Addendum No. 04

Subject: James Logan Elementary School Toilet Room Renovations
SDP Contract Nos. B-001C, B-002C, B-003C, B-004C of 2020/21

Location: James Logan Elementary School, 1700 Lindley Avenue, Philadelphia, PA 19141

5 BOYS RESTROOM 001 - NEW WORK PLAN
A-150 SCALE: 1/4" = 1'-0"

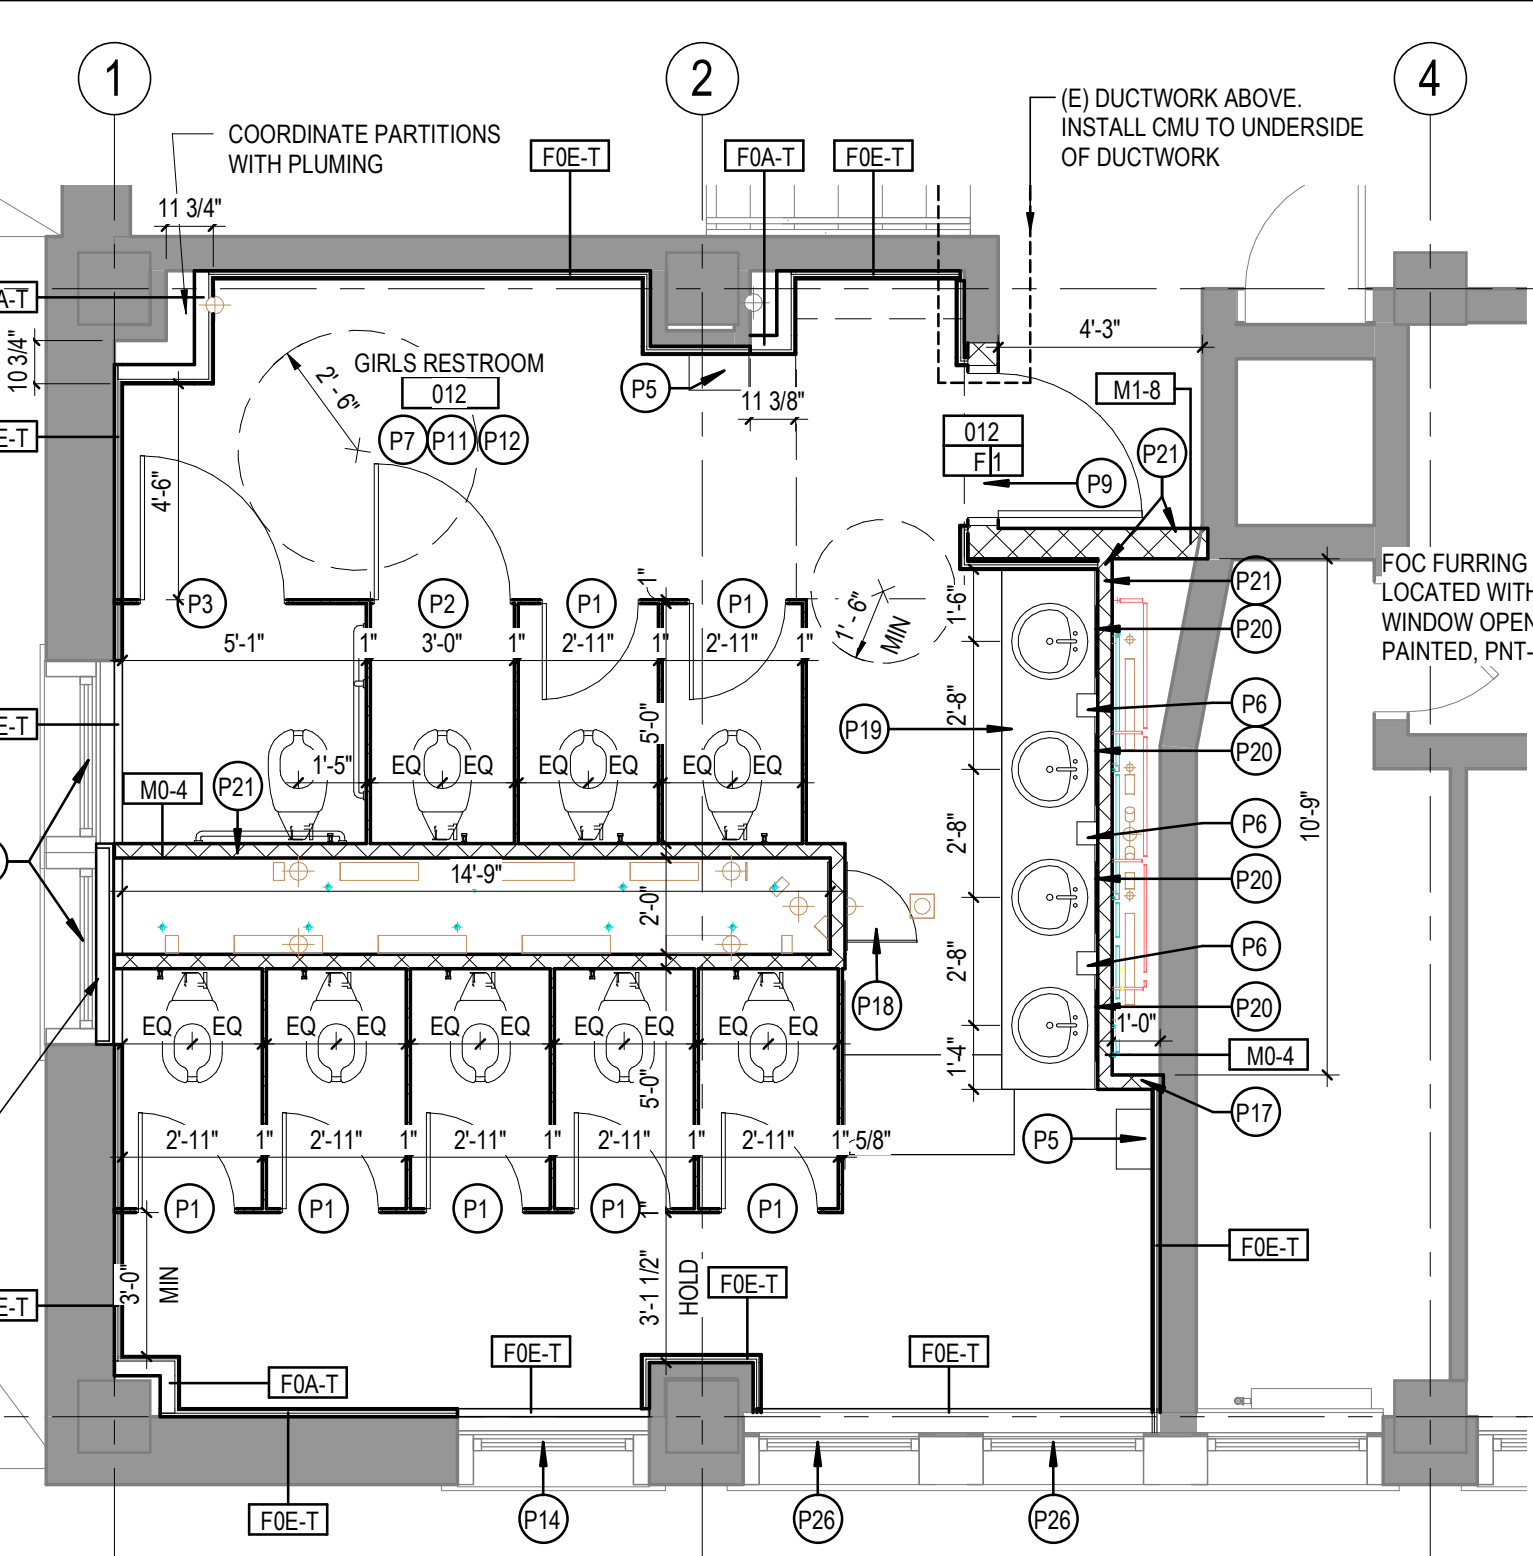
Drawing 5/A-150

7 HEADSTART RESTROOM 001A- NEW WORK PLAN
A-150 1/4" = 1'-0"

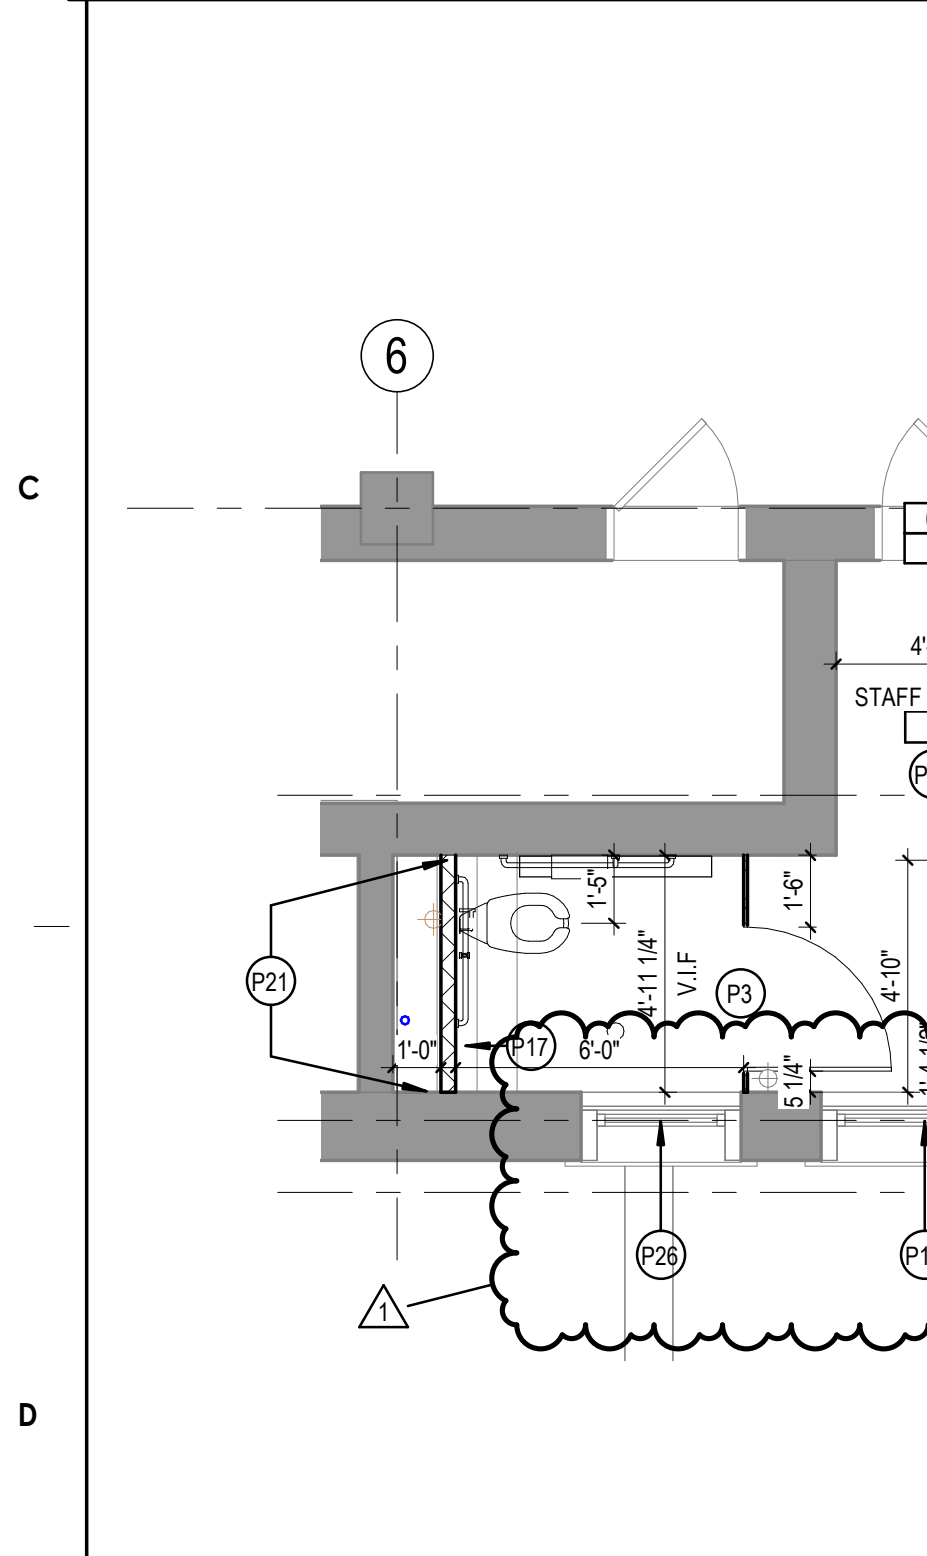
Drawing 7/A-150 has been modified as follows:

8 STAFF RESTROOM 014 - NEW WORK PLAN
A-150 1/4" = 1'-0"

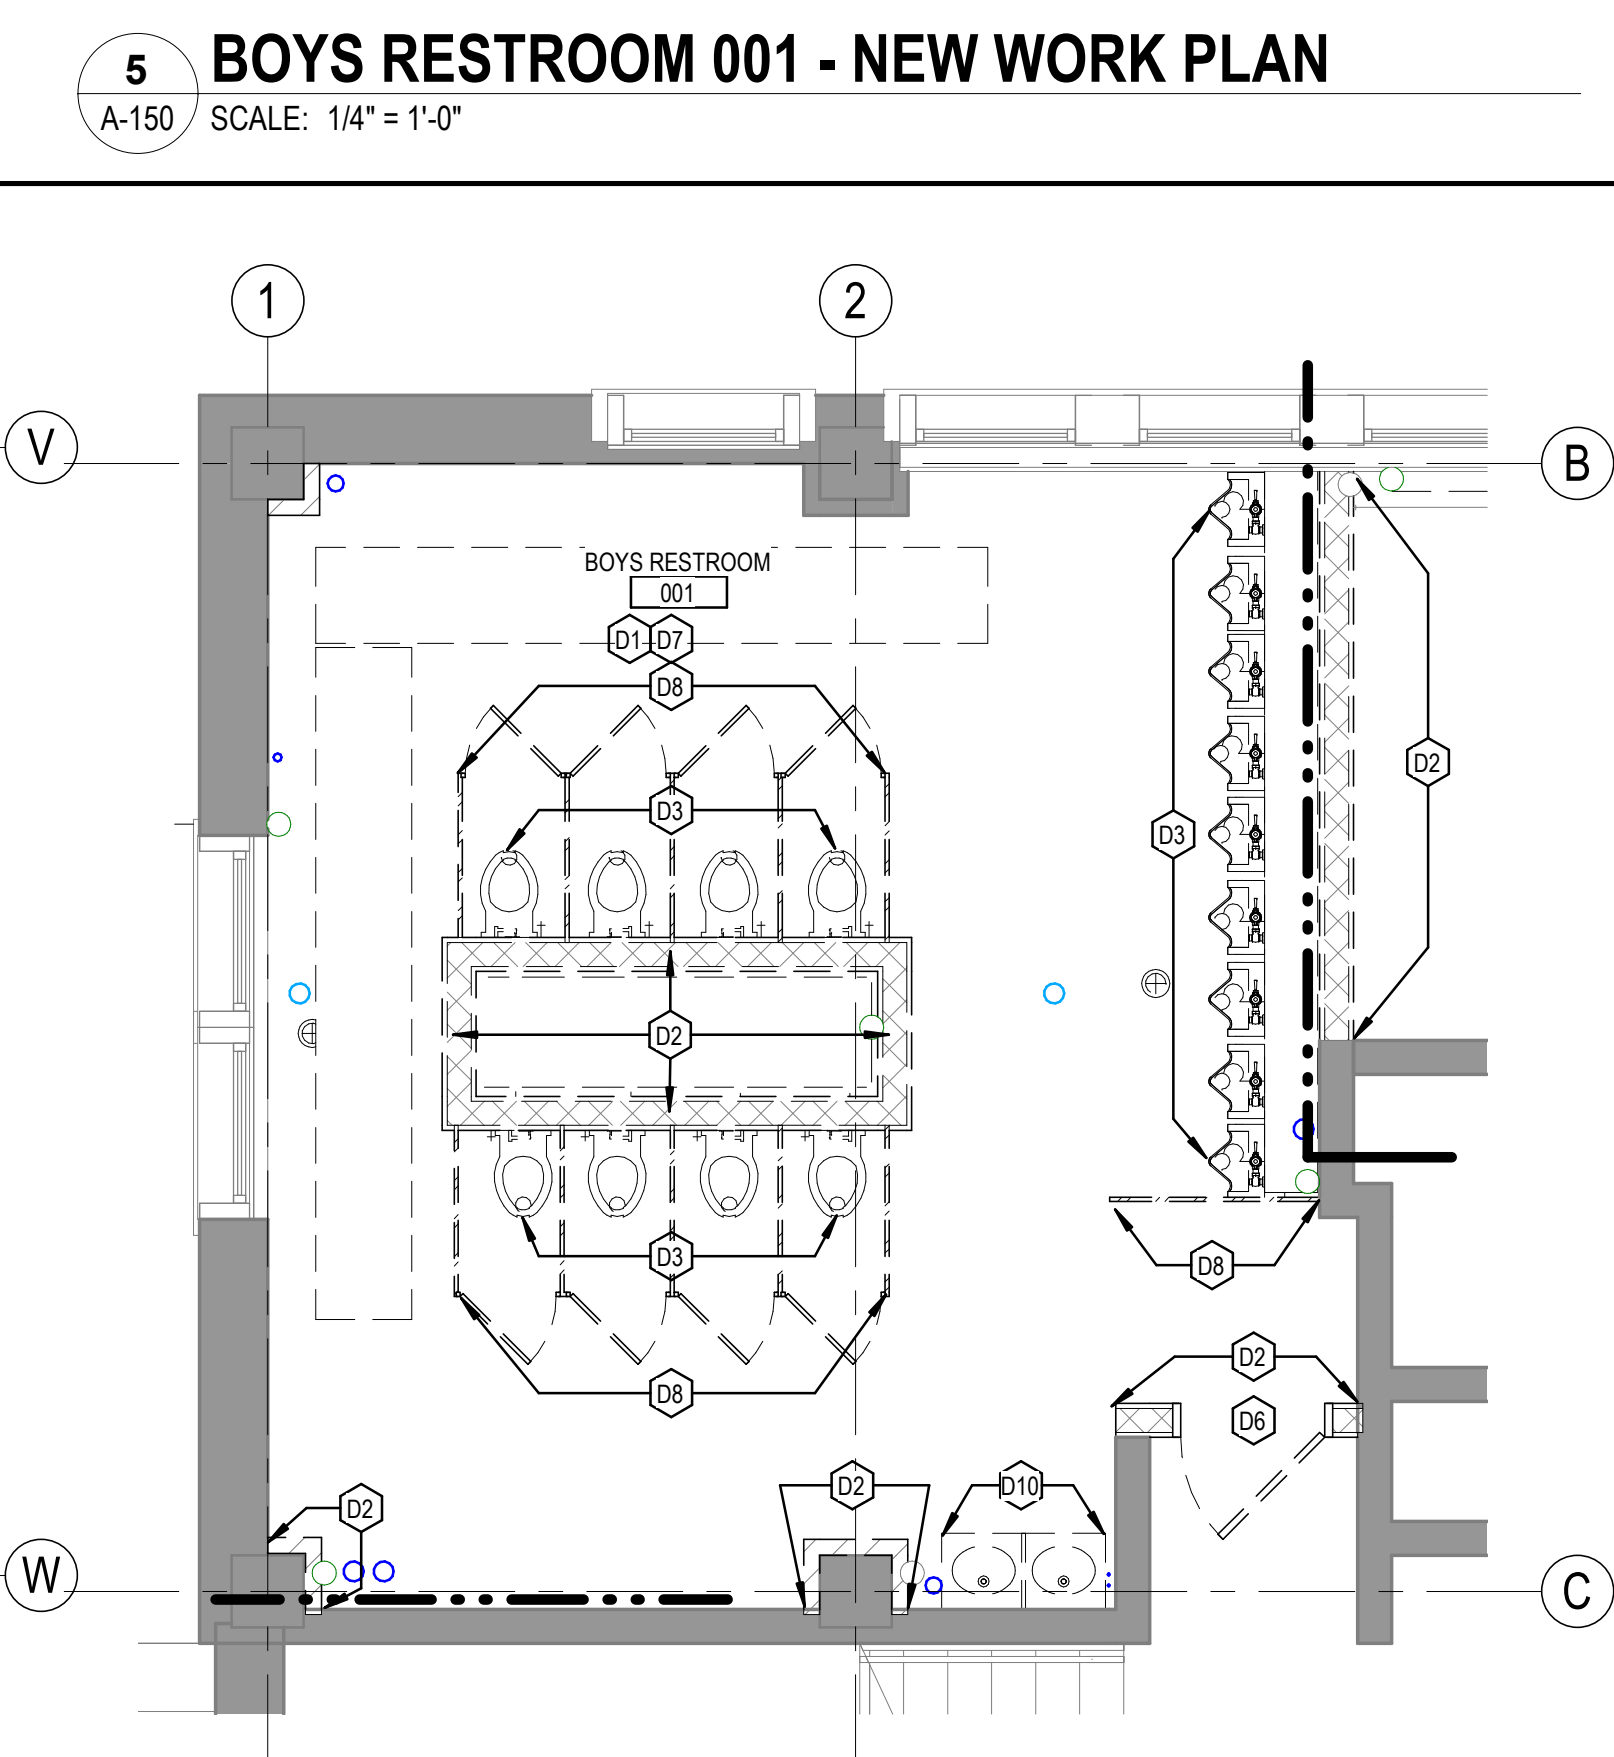
Question 8: Detail 8/A-150 for the Staff Restroom 014: There is no vanity and lav bowl shown for this room. Is a new vanity and solid surface lav bowl intended but not shown?

Drawing 8/A-150 has been modified as follows:
